This Preliminary Amendment is for currently filed patent application number 10/648,058, filed on August 26, 2003. This amendment makes changes to the form, not substance, of the formal drawings submitted on February 19, 2004. This amendment corrects errors in the formal drawings. Further, these changes are consistent with the specification of the above-identified patent application.

Serial No. 10/648,058 Inventor: YATES, John SAFETY BELT WEB ADJUSTER Attorney Docket: 31104-6

Annotated Marked-Up Drawing

Fig. 4

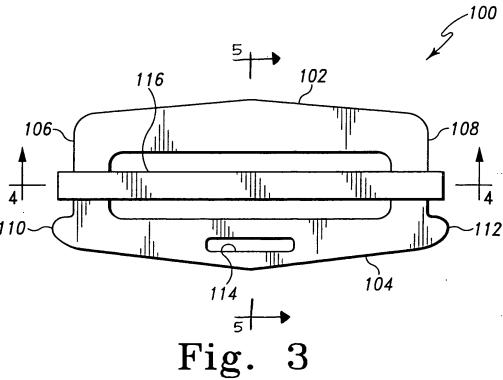
Regarding Figs. 1, 2 and 4, currently no amendments are being made. Regarding Fig. 3, a section line 5-5 has been added to clarify from where the view shown in Fig. 5 is taken. Regarding Figs. 5 and 6, horizontal member 116 was previously shown in the same plane as the horizontal members 102 and 104 of the web adjuster 100. However, in order for the web adjuster 100 to operate properly and lock the seat belt webbing portions 132 and 134 in place, the horizontal member 116 must be able to slide over the vertical members 106 and 108, as shown in Fig. 4. In Figs. 5 and 6 as originally filed, the vertical members 106 and 108 are incorrectly shown in the same plane as the horizontal members 102 and 104. Therefore, Figs. 5 and 6 have been amended to show the proper location of horizontal member 116, which is offset from the plane created by the horizontal members 102 and 104. The amended drawings now show the ability of the horizontal member 116

Fig. 6

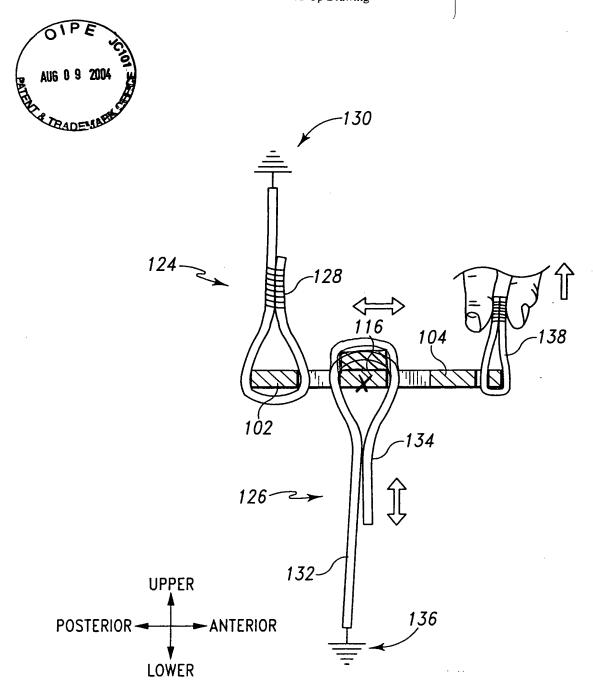
to slide freely over the vertical members 106 and 108, as clearly shown in Figs. 3 and 4 as originally filed, and as disclosed in the specification as originally filed.
